*Appendix A*  
*Applicant Responses to Selected PPRP Data Requests*

**CASE NO. 9483**

**CITIZENS UB SOLAR LLC  
RESPONSE TO PPRP DATA REQUEST NO. 1  
RESPONSE DATE: September 4, 2018**

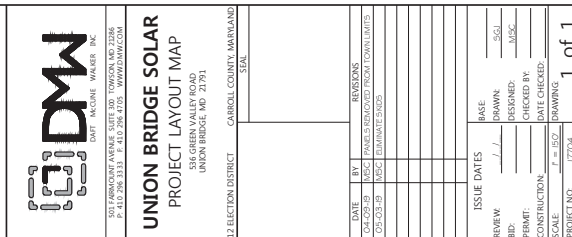
**Item No.: PPRPDR5-2** Page 19 of Applicant's Revised ERD states there will be "three (3) separate transformer pads each with one (1) transformer per pad." Page 9, Figure 6 states there will be 33 transformers integrated on skids with inverters. Page 8, Figure 5 appears to show four transformer pads within the project boundary.

- a) Please confirm the number of transformers for the project.
- b) If necessary, please provide an updated Figure 5.

- a) The number of transformers proposed for the project is 2. All sections should read, "there will be two (2) separate equipment pads, each with one (1) transformer per pad."
- b) *Attachment A* is an updated Figure 5 with the appropriate locations of the two (2) equipment pads.

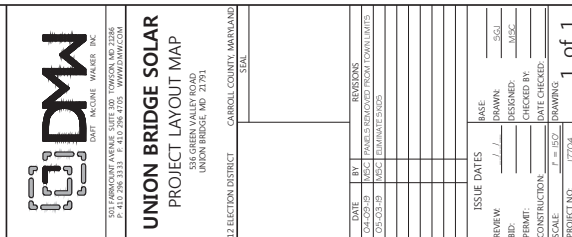
**Item No.: PPRPDR5-11** Section 4.D.1 of the Applicant's Revised ERD indicates that no forests will be cleared, and Section 5.A of the Revised ERD indicates a 35' setback from the drip line of the wooded perimeter of the project. However, Figure 5 in the Revised ERD appears to show access roads encroaching into existing forest stands.

- a) Please define the acreage and approximate number of trees to be cleared, and provide a revised description of the setbacks along the wooded perimeter of the project.
- b) If the access roads will not encroach on the drip line of the wooded perimeter, please provide a high-resolution electronic copy of the revised site plan illustrating the locations of the access roads and fences.

- a) The Applicant is not proposing to cut trees for the project. It is the Applicants intent to provide thirty-five feet (35') from the dripline of the trees to the panels in all locations.
- b) As noted in **DR5-3**, Figure 5 reflects a thirty-five percent (35%) design level. The tree line locations are still being refined as they have not yet been surveyed. What is shown on Figure 5 is an approximate location. It is still the Applicants intent to provide thirty-five feet (35') from the dripline of the trees to the panels in all locations. Field located the dripline of the trees will be done during the local site plan process and civil design plans will be updated accordingly.

The access road shown in Figure 5 is based on an actual existing road/cut-through within the tree lines which crosses the previous railroad right-of-way.
